Form C-103

7. Lease Name or Unit Agreement Name  
Cato San Andres Unit

8. Well Number 196

**SUNDRY NOTICES AND REPORTS ON WELLS**  
(DO NOT USE THIS FORM FOR PROPOSALS TO DRILL OR TO DEEPEN OR PLUG BACK TO A DIFFERENT RESERVOIR. USE "APPLICATION FOR PERMIT" (FORM C-101) FOR SUCH PROPOSALS.)

**PROPOSED  
30-005-20598**

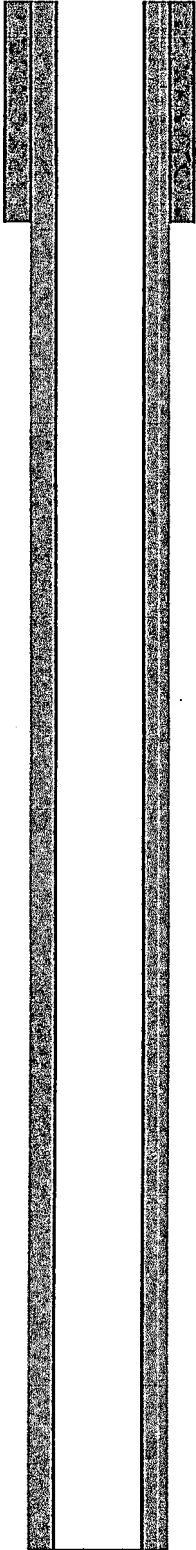
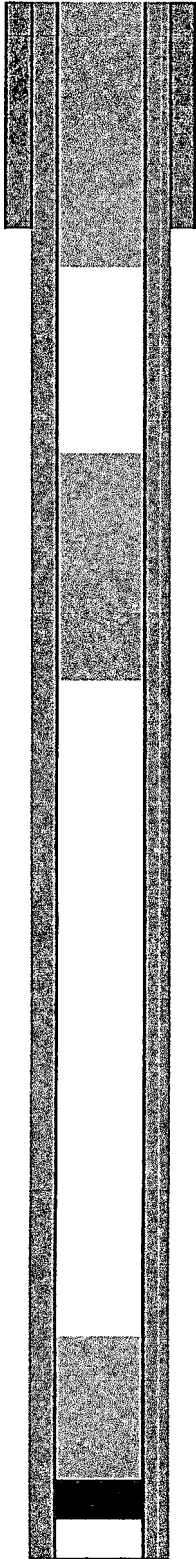
\*\*\* SEE ATTACHED COA'S  
MUST BE PLUGGED BY  
2/24/21

1. Set CIBP at 3208'.
2. Circulate mud laden fluid. Pressure test casing.
3. Spot 25 sx cmt on CIBP.
4. POOH to 1375'. Spot 55 sx cmt. WOC & Tag. (Covers Salt)
5. POOH to 309'. Fill to surface w/ cmt. *Perf @ 309'*
6. Cut off wellhead. Verify cement to surface all strings. Install dry hole marker.

14. All Casing Shoes Will Be Perforated 50' below shoe depth and Attempted to be Squeezed, cement needs to be 50' above and 50' Below Casing Shoe inside the Production Casing.

17. A CIBP is to be set within 100' of production perforations, capped with 100' of cement, WOC 4 hours and tag.
18. A CIBP with 35' of cement may be used in lieu of the 100' plug if set with a bailer. This plug will be placed within 100' of the top perforation, (WOC 4 hrs and tag).
